DEVELOPMENT REVIEW COMMITTEE (DRC) COMMENT REPORT

PROJECT NAME: 475 Apartments

CASE NUMBER: UDP-S20017

REQUEST: Site Plan Level II Review: 52 Multi-Family Residential Units

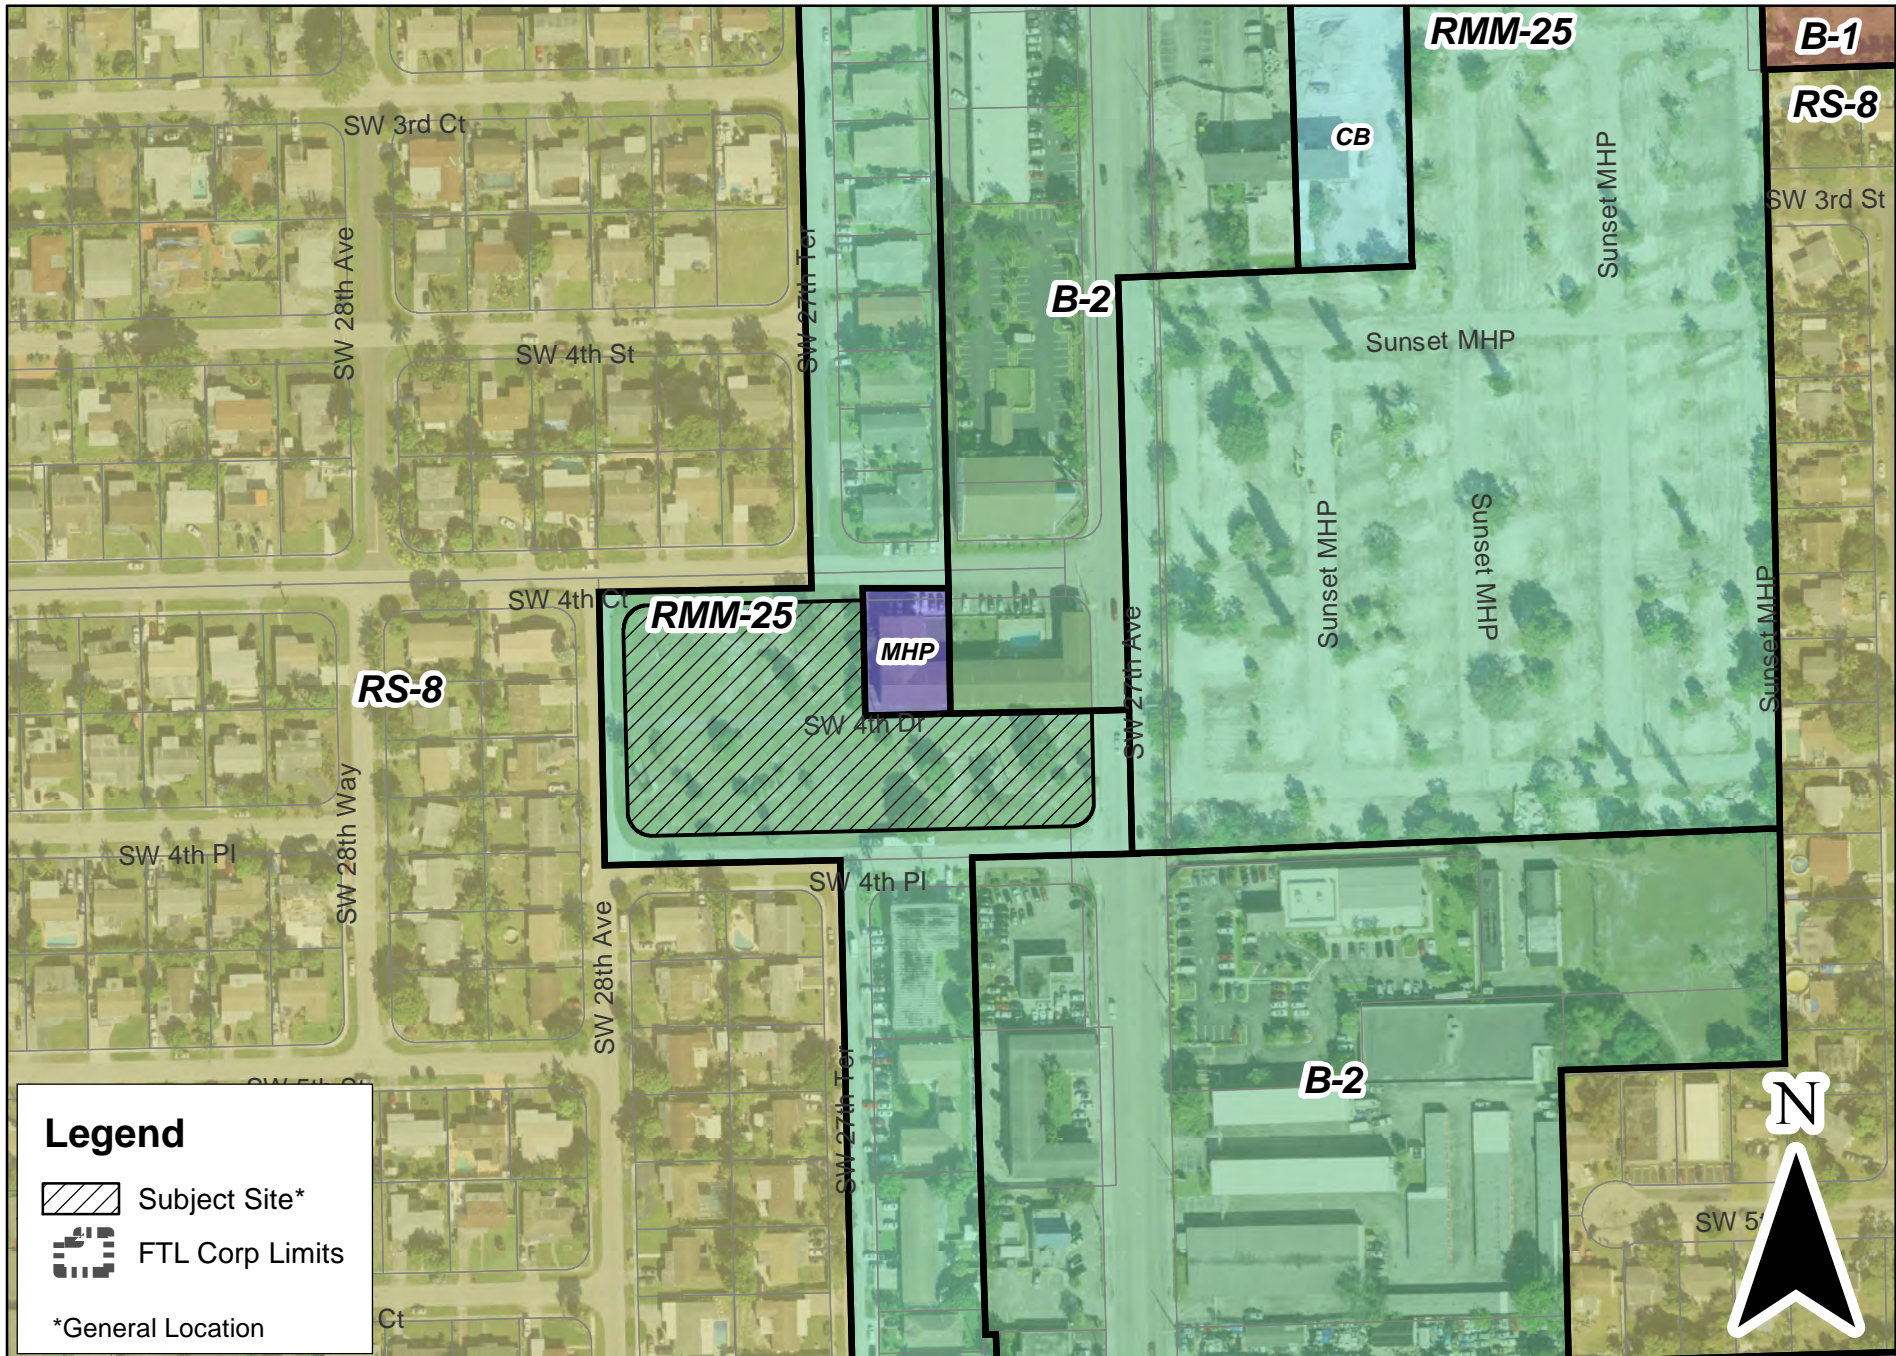
- 15) It is strongly recommended that bicycle parking in visible, well-lit areas as close as possible to pedestrian entryways/doors is provided. In addition where possible, locate bicycle parking facilities in an area that is sheltered/covered. Show internal secured bicycle racks and/or external bike racks on the site plan. Consult the Association of Pedestrian and Bicycle Professionals ("APBP") for Bicycle Parking Guidelines and Broward County End-of-Trip Bicycle Facilities Guide at <http://www.apbp.org/>. For more information on bicycle parking standards, please email the Transportation and Mobility Department DRC listed in this report.
